NAVARRO HS ATHLETICS COMPLEX  
SEGUIN, TEXAS  
Developed for  
NAVARRO INDEPENDENT SCHOOL DISTRICT

Revision	Date	Description
1	03/27/2025	PKG. 3 ADDENDUM 1
6	06/18/2025	PR-01 PERMIT COMMENTS
8	08/15/2025	PR-02
13	09/04/2025	PR-05
15	09/04/2025	PR-11
27	04/21/2026

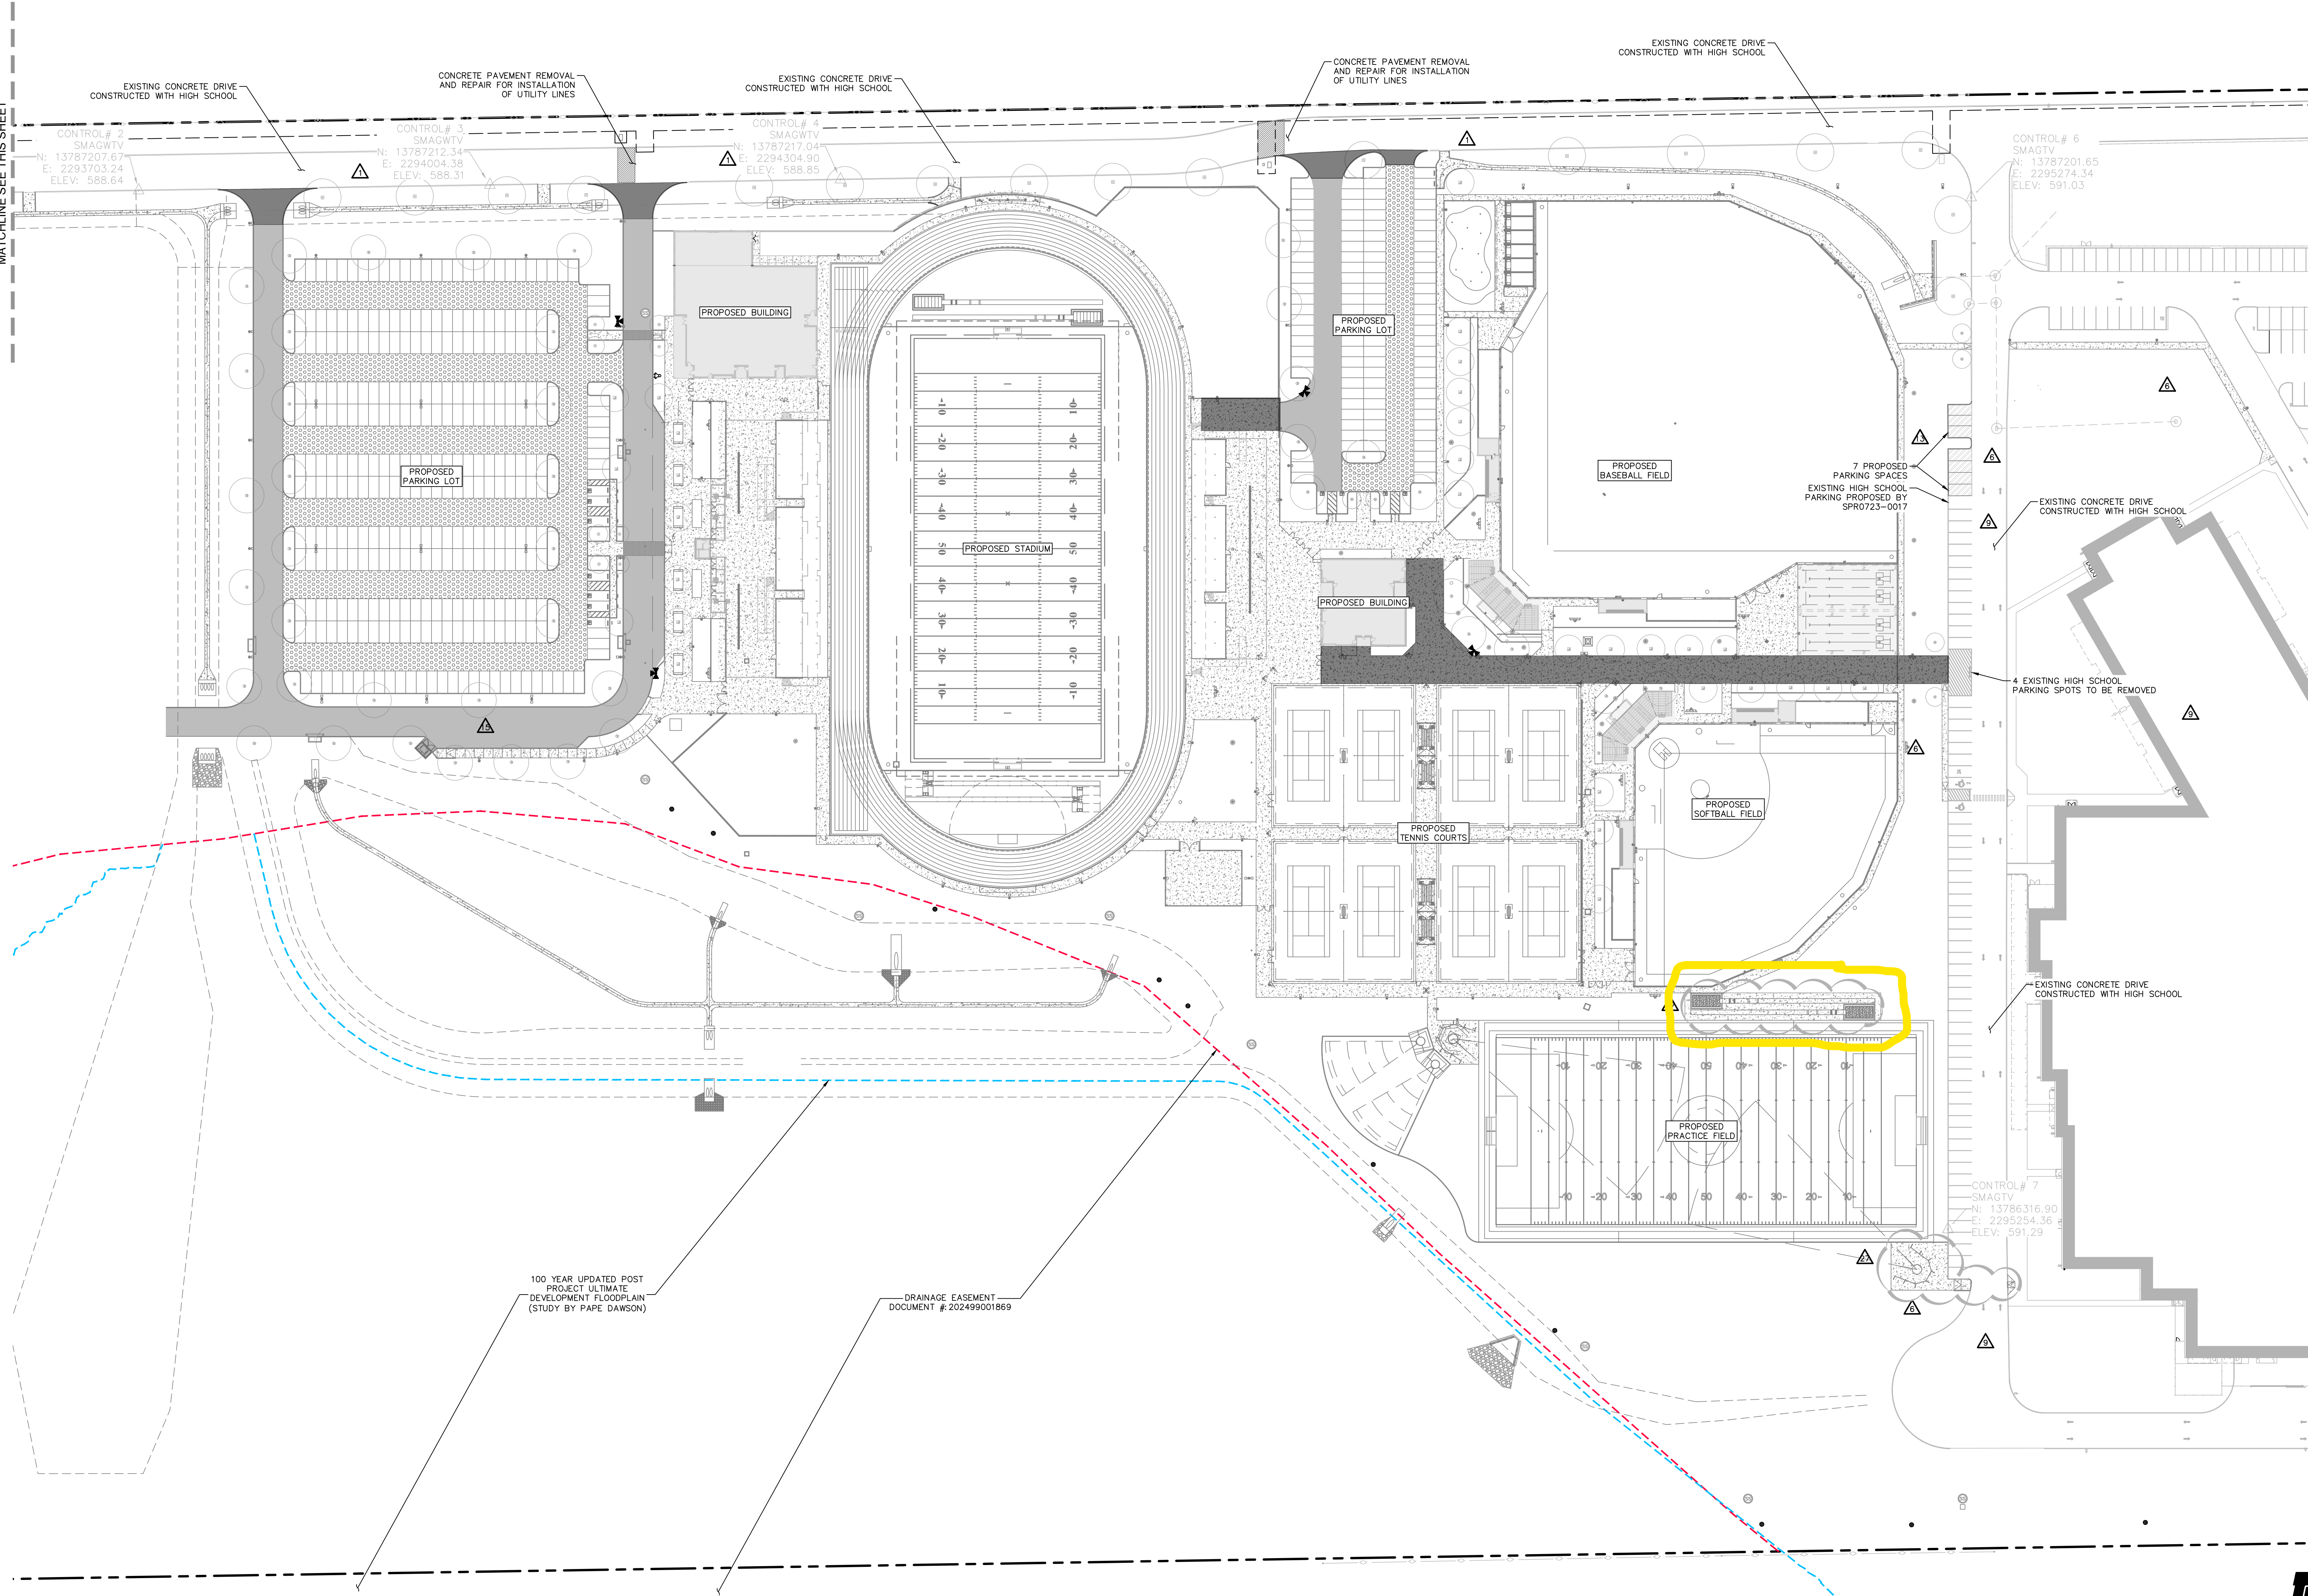
NOTE:  
PR #11 IMPERVIOUS COVER INCREASE: 0.108 AC (4,683 SF)
